To: T10 Technical Committee
From: Rob Elliott, HP (elliott@hp.com)
Date: 12 March 2007
Subject: 07-089r0 SAS-2 Redundant primitive sequence error handling

Figure 148 — Triple primitive sequences

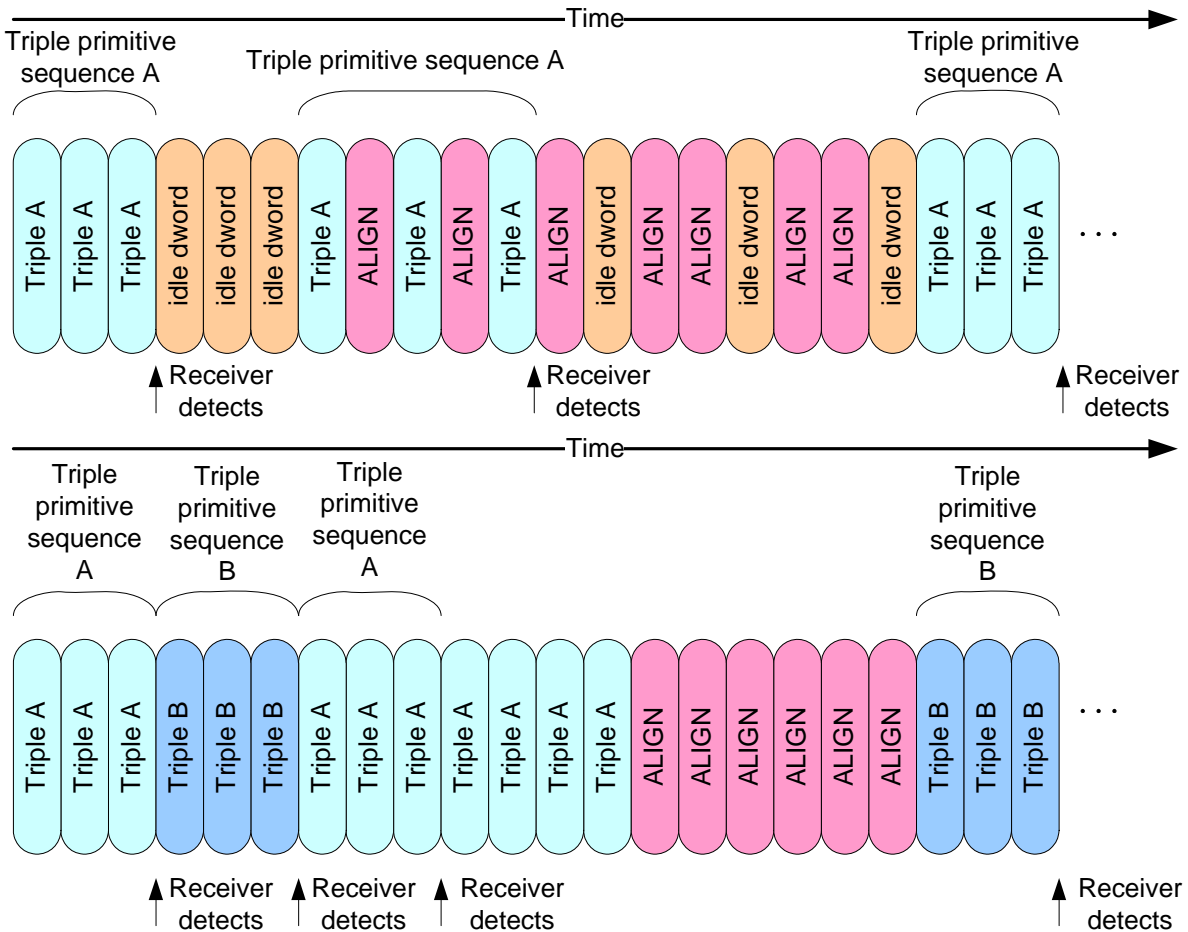
[A triple primitive sequences that begins within five dwords of a redundant primitive may or may not be detected \(see 7.2.4.7\).](#)

Figure 149 — Redundant primitive sequences [\[modified\]](#)

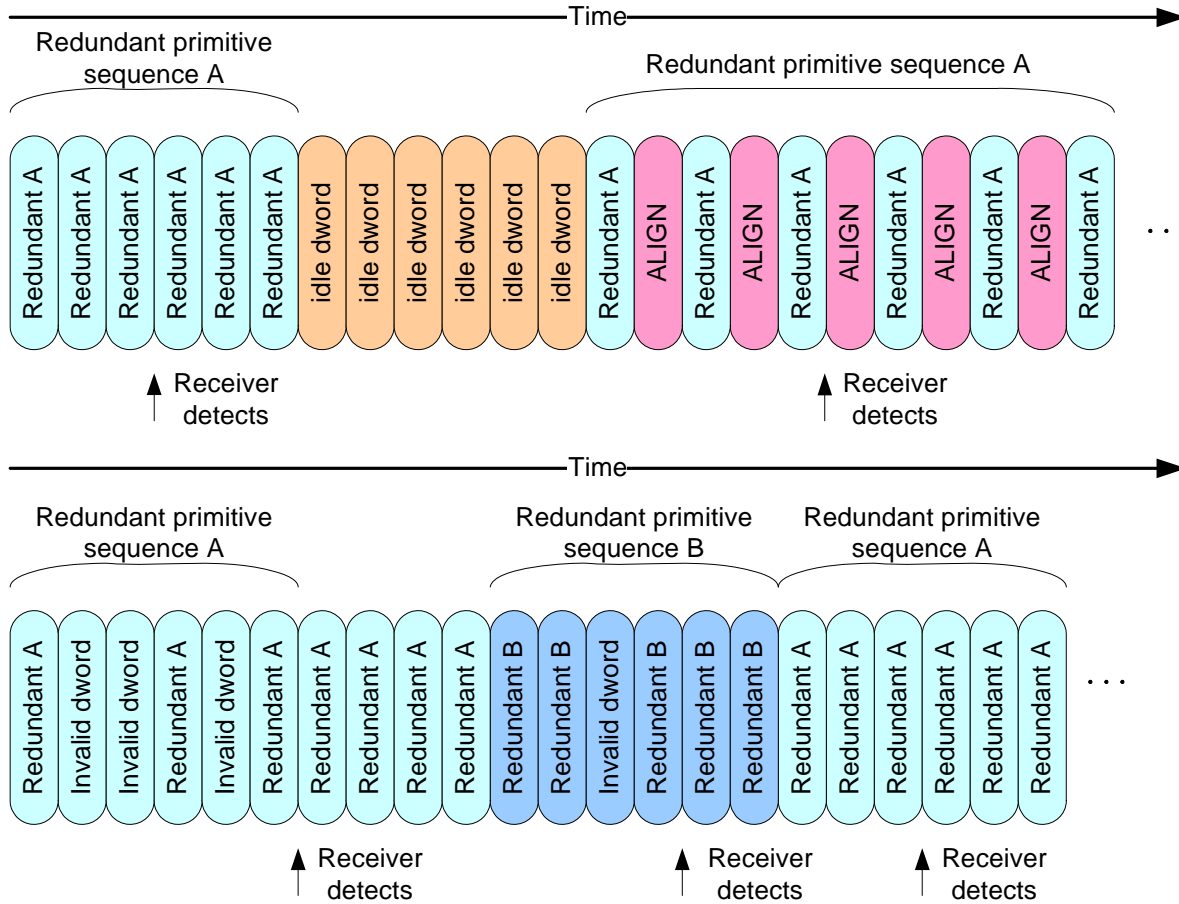
[After detecting a redundant primitive, the receiver may or may not detect another redundant primitive sequence or a triple primitive sequence that occurs within the next five consecutive dwords. Table 2 shows examples of interleaved primitive sequences.](#)
